DEVELOPMENT COMMITTEE

Application for Planning Permission

Reference	PA/22/01910
Site	22 Senrab Street, London, E1 0QE
Ward	Stepney Green
Proposal	Proposed roof extension to create 2 additional bedrooms, 2 new rooflights to front elevation and a new biodiverse roof top to existing rear first floor roof and associated external alterations.
Summary Recommendation	Refuse planning permission
Applicant	Mr Volker Gulde
Agent/ architect	WorJKshop
Case Officer	Lauren Ford
Key dates	<ul style="list-style-type: none">- Application registered as valid on 21/09/2022- Public consultation finished on 04/11/2022

Figure 3: Scheme dismissed at appeal - Rear Elevation

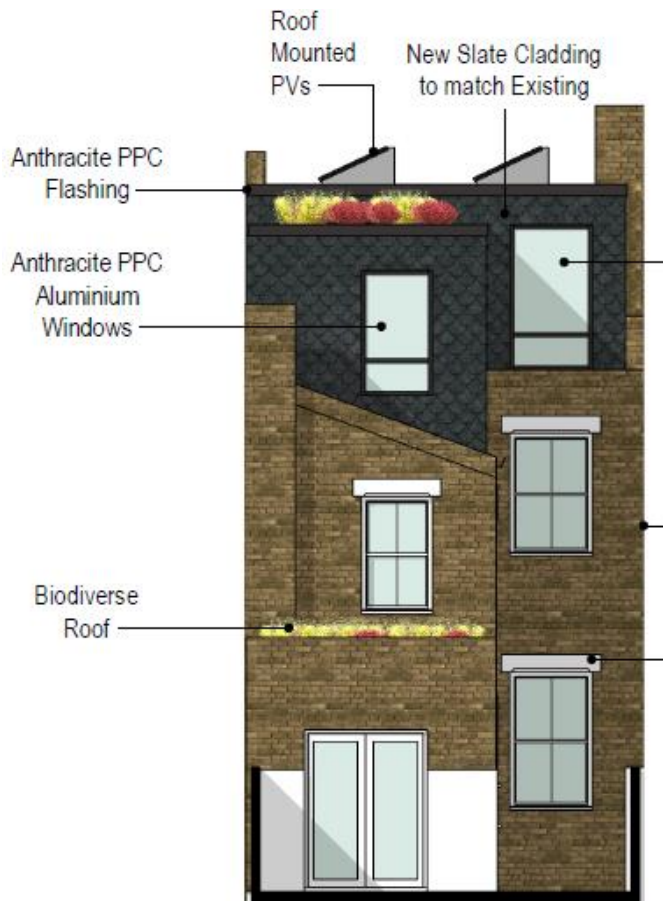
- 7.9 The following is a summary of the Inspectors assessment of the appeal scheme, as outlined in the appeal Decision. The Inspector stated that the proposal would introduce a significant amount of built form to the rear of the dwelling and that its size and imposing form would fail to harmonise with the modest scale and proportions of the property. He noted that there would be clear views of the development from Head Street, looking into the conservation area, where the proposal would be viewed in the context of the rear façade of the wider terrace. There are three properties in the wider terrace that have existing rear roof extensions and the Inspector noted that these existing extensions are prominent and discordant; and all approved prior to the inclusion of Senrab Street in the Conservation Area. Apart from these limited examples, he notes that the roofscape remains largely unaltered, creating a distinctive rhythm of traditional roofs, outriggers and parapet walls, which all contribute positively to the character of the Conservation Area.

- 7.10 The Inspector states that the proposal would further erode the traditional, modest character of the roofscape from the rear, which would harm the character and appearance of the conservation area. The Inspector equated the level of harm with 'less than substantial'.

7.11 In weighing the harm against the public benefits of the scheme, the Inspector noted that the proposal would increase and improve the accommodation, which was largely a private benefit and which carried only limited weight as a public benefit. The biodiversity and energy benefits would be small and overall, these public benefits would not outweigh the harm caused to the significance of the designated heritage asset.

Appendix 2.1: Existing (left) and proposed (right) rear elevations

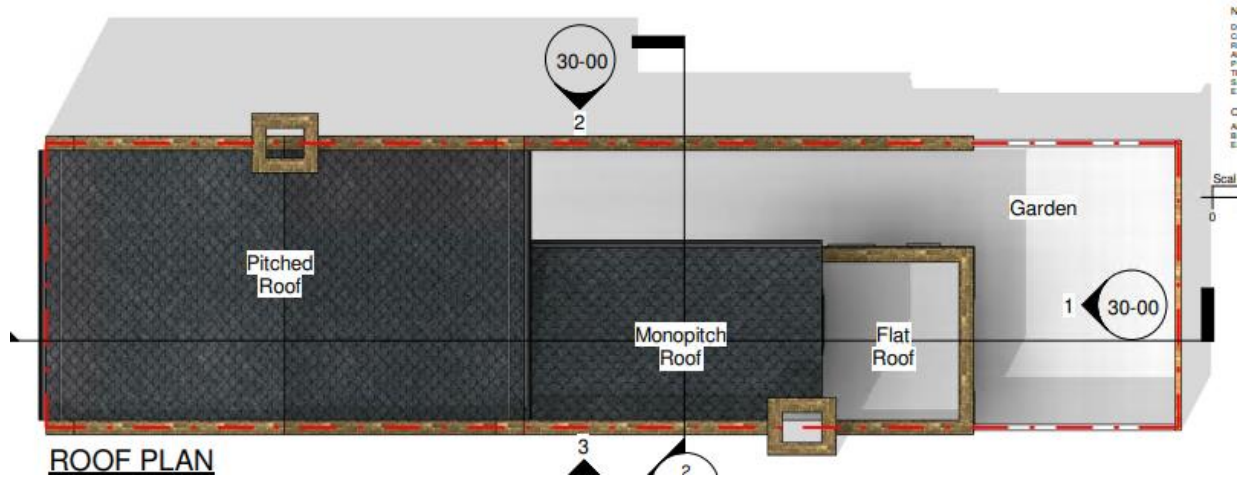
7.15 While the applicant has made changes to the scheme in a bid to address the previous reason for refusal and dismissal at appeal, the proposed scheme is not considered to be sufficiently different in size or design, to address the concerns. While the bulk of the extension has been reduced to some degree, the amount of built form remains materially similar to the appeal scheme, as can be seen in the comparison images above. The resulting proposed roof extension, by reason of its excessive size and bulk, would obscure the traditional lines of the roof and appear entirely out of scale with the modest host property. It would be a visually intrusive and discordant form of development, degrading the largely unaltered and traditional rear roof form of the terrace- which has been identified for its positive contribution to the significance of the conservation area.

- 7.18 The extension would be clearly visible from Head Street, looking into the conservation area and the proposal would neither preserve nor enhance the conservation area's special character. The visual harm to this part of the conservation area would equate to 'less than substantial' harm to the conservation area as a whole. Given the above, the proposal would fail to comply with Policies S.DH1 and S.DH3 of the Tower Hamlets Local Plan 2031.
